STAFF REPORT
(Preliminary Plat)

CASE NUMBER: S/D 96-22 REGENCY LAKES ADDITION

STAFF REPORT
(Final Plat, Preliminary Plat Approved 5/9/96)

CASE NUMBER: S/D 96-22 REGENCY LAKES ADDITION

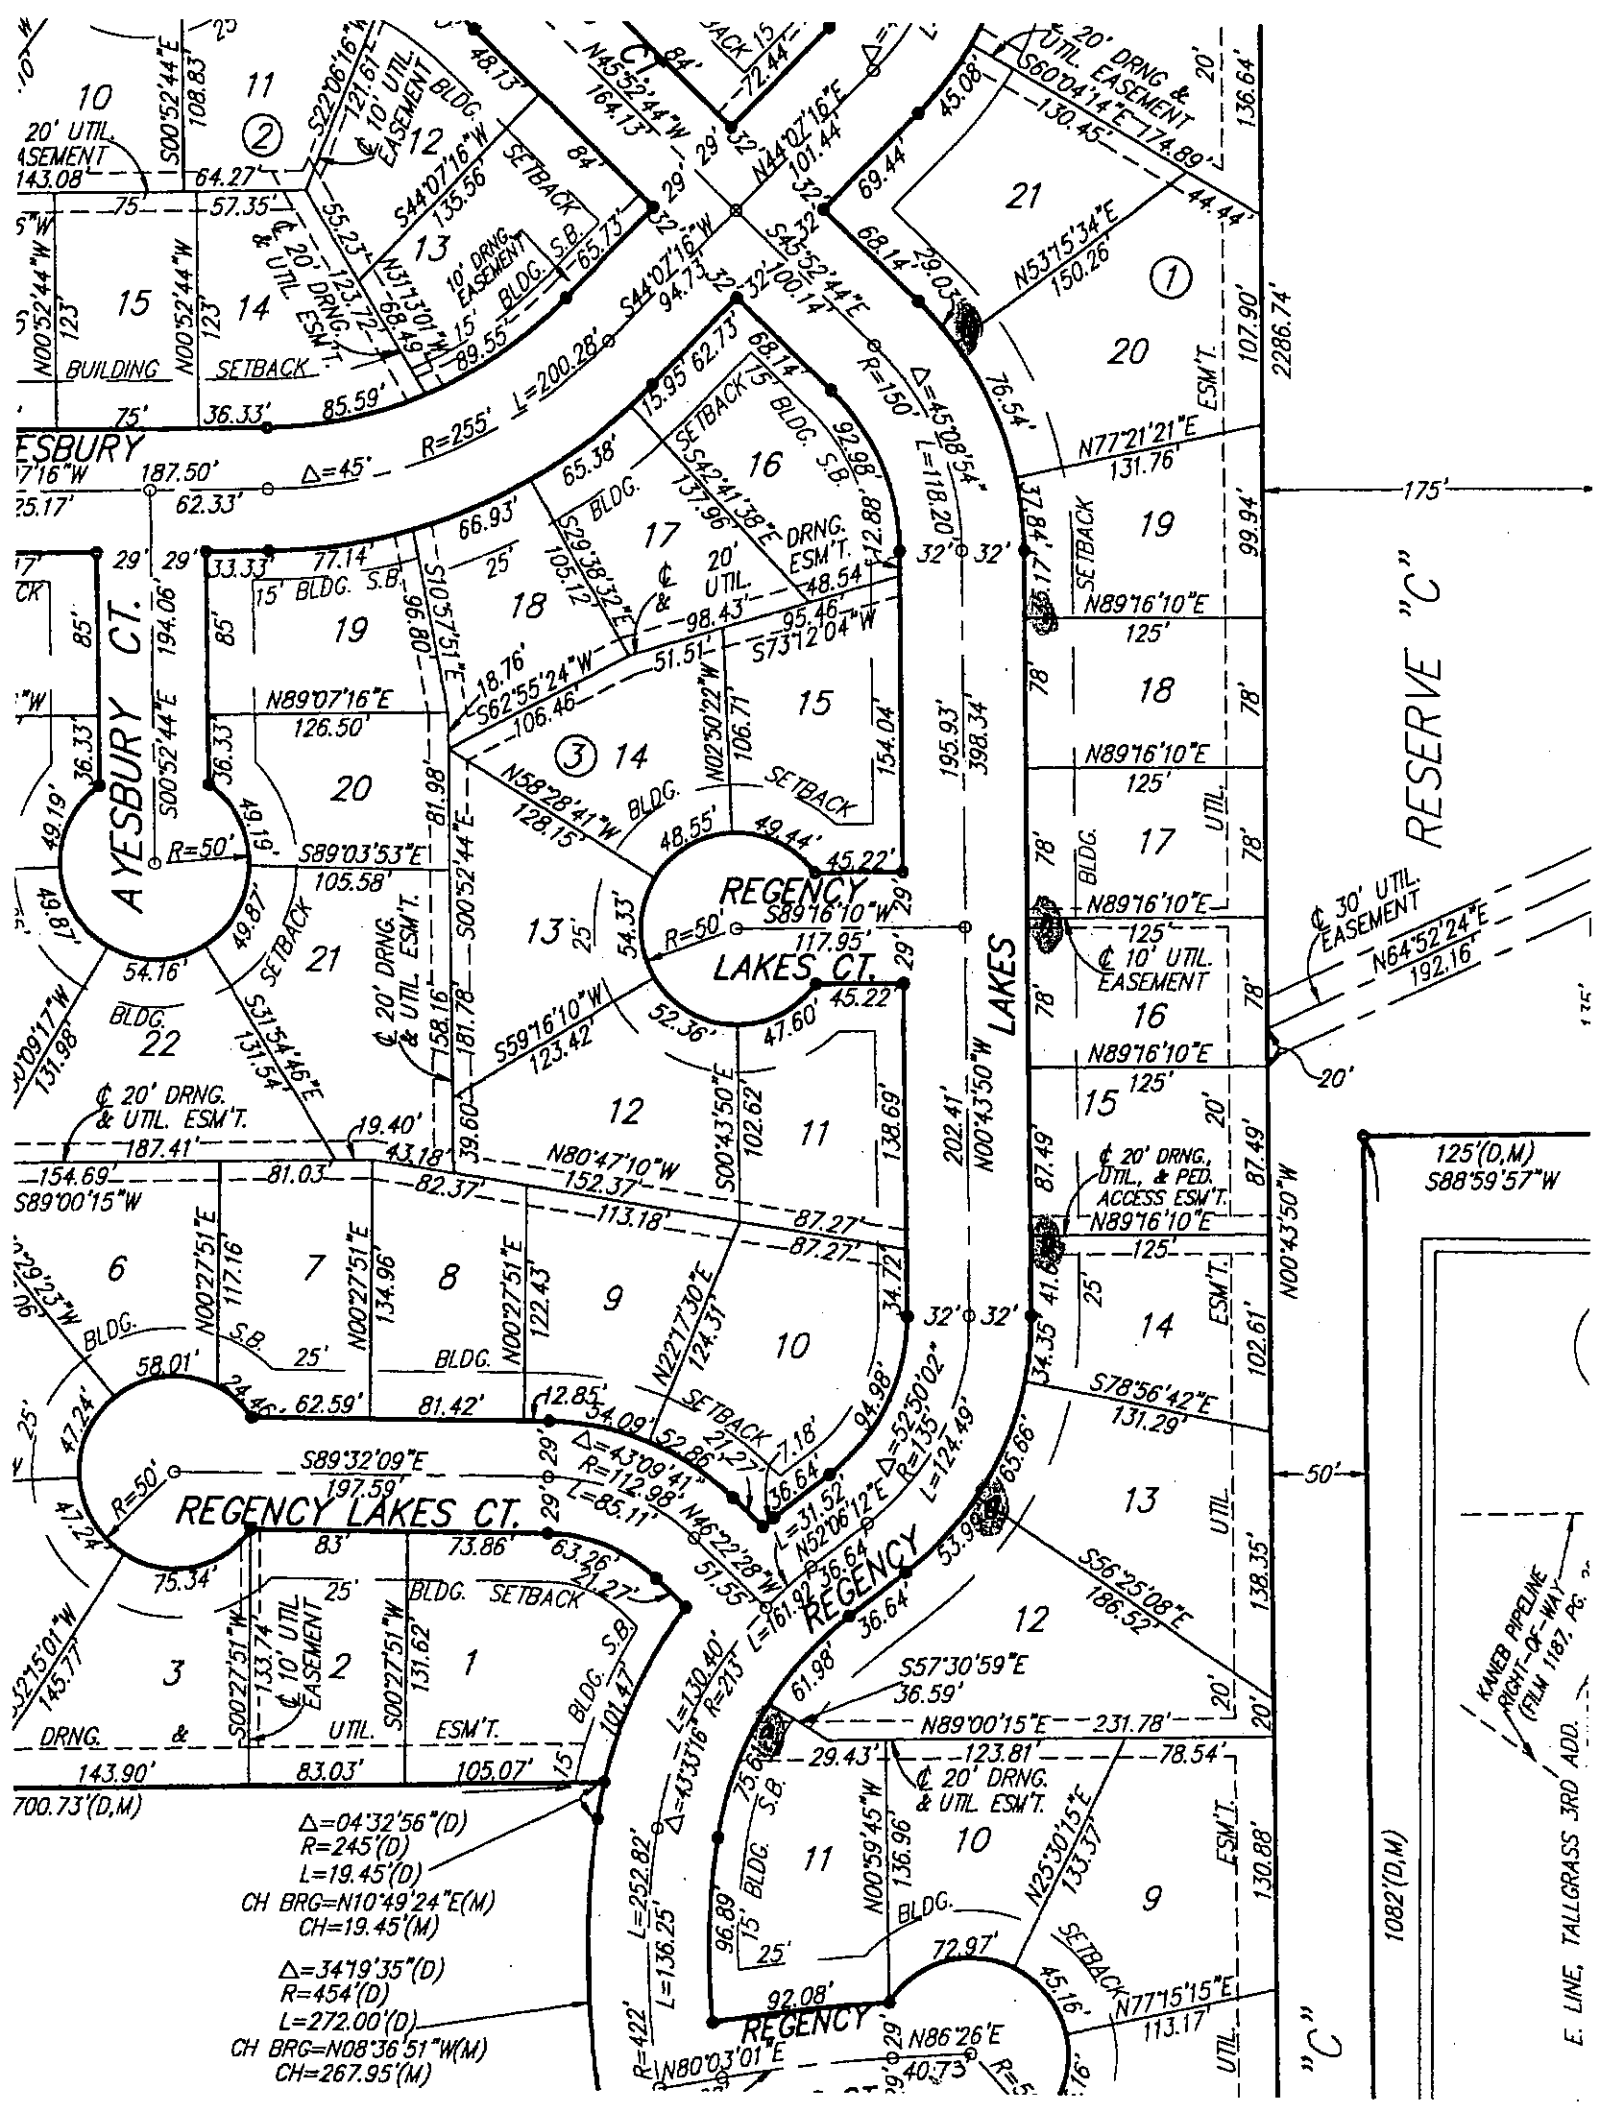
It has been called to our attention by the Office of Central Inspection and the Fire Department that "No Parking – Fire Lane" signs will be required on Regency Lakes street until such time that Regency Lakes Second, Lot 2, is developed to provide emergency access to Brandon Circle from the south. The developer has requested that the cost and installation of these signs be funded with a change order for the Phase 2 street project. This petition has excess funds and can absorb the extra cost. Enclosed please find a detail of the proposed sign along with a plan showing the proposed locations of the signs (10 total) as approved by the Fire Department.

TOP LEFT
 COLORS: LEGEND - WHITE
 BACKGROUND - RED

TOP RIGHT & BOTTOM
 LEGEND - RED
 BACKGROUND - WHITE

* REDUCE SPACING 60%

** REDUCE SPACING 50%
